Landmarks Board

October 12, 2016

STAFF REPORT

LOCATION: 601 St. Louis Street

Attachment A

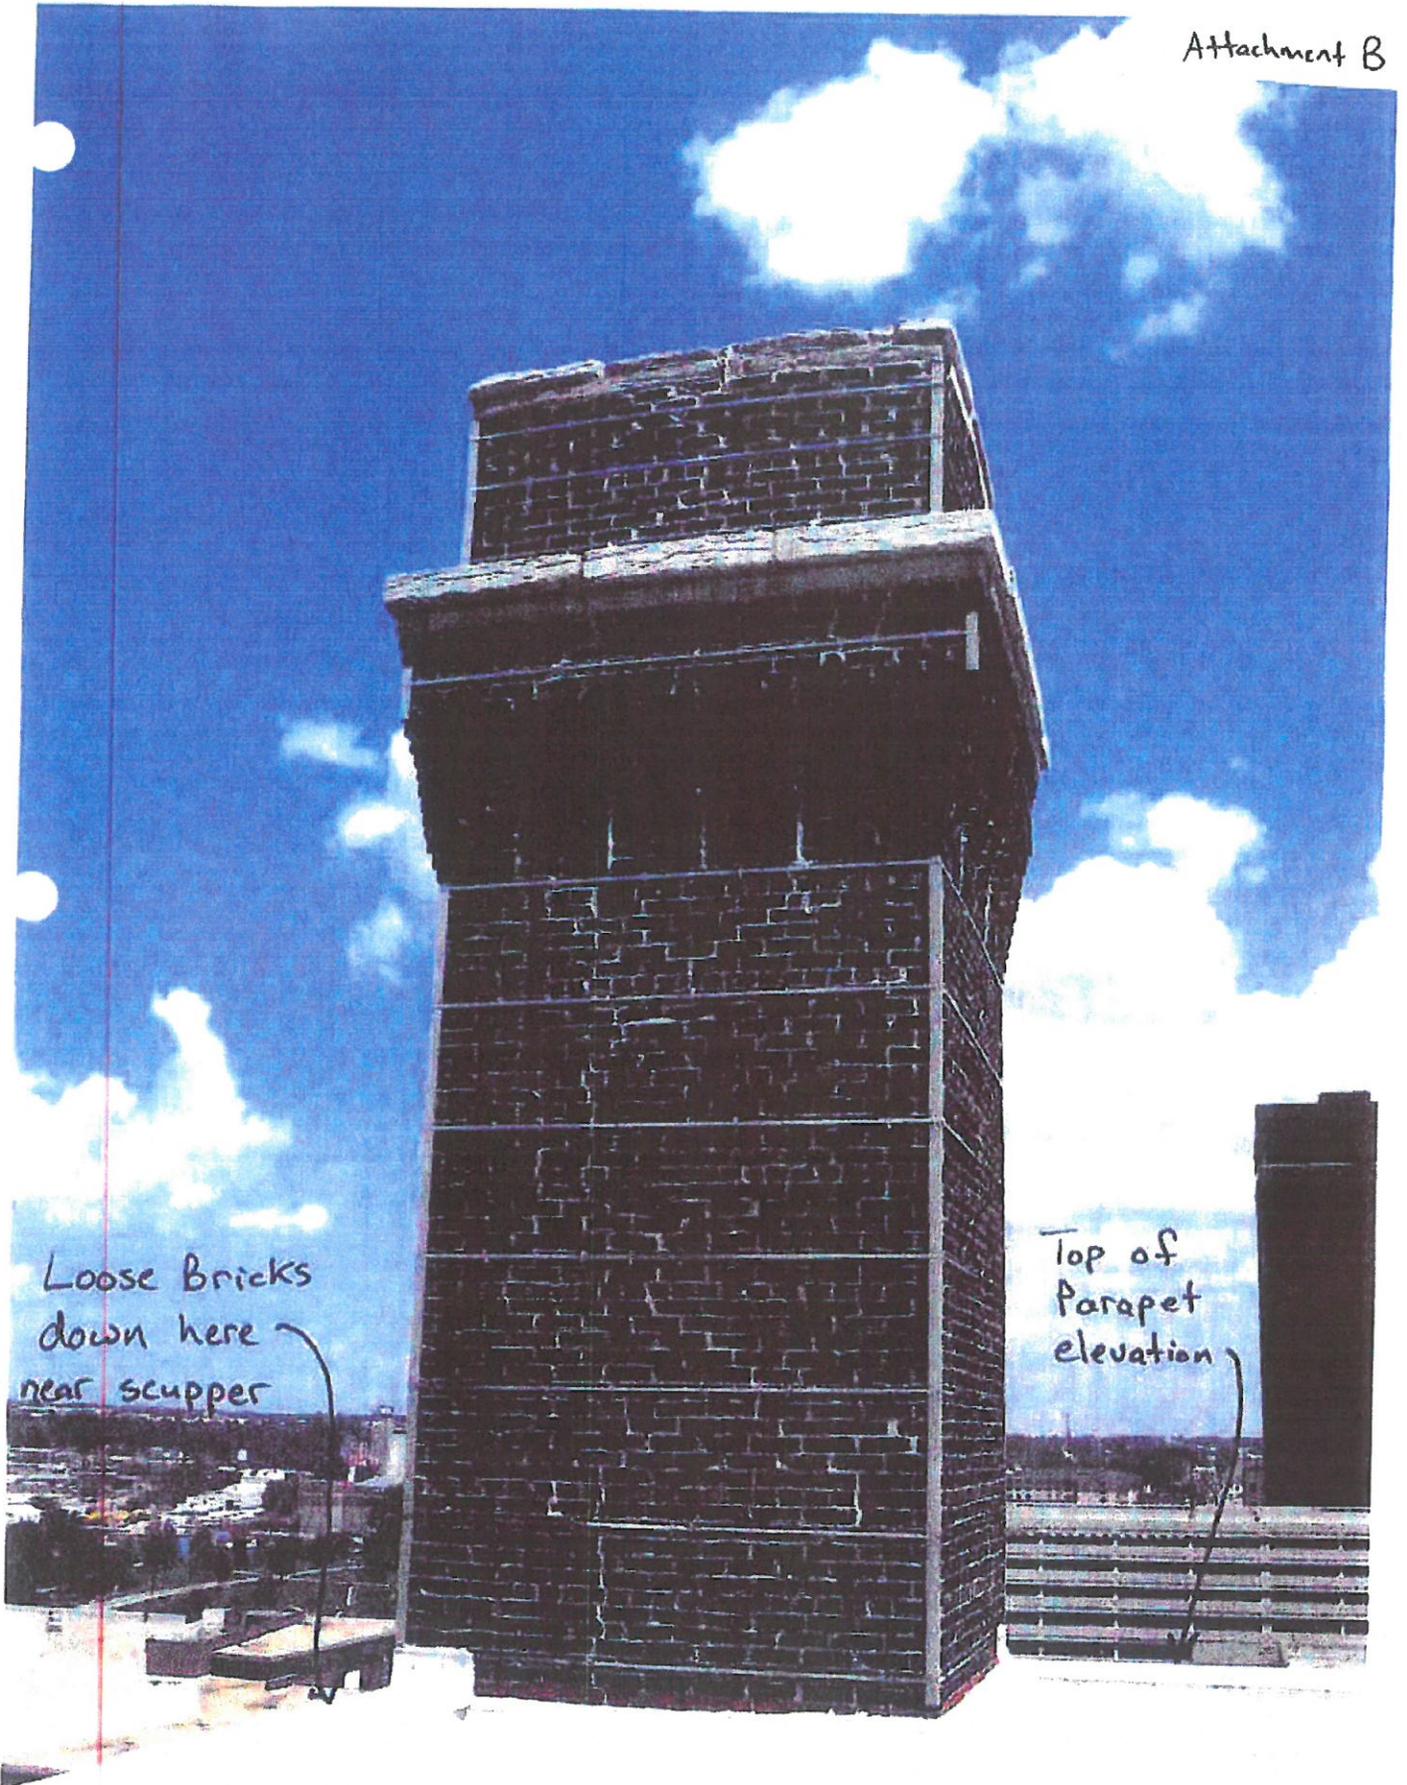
Large
Bulge

Loose Bricks
down here
near scupper
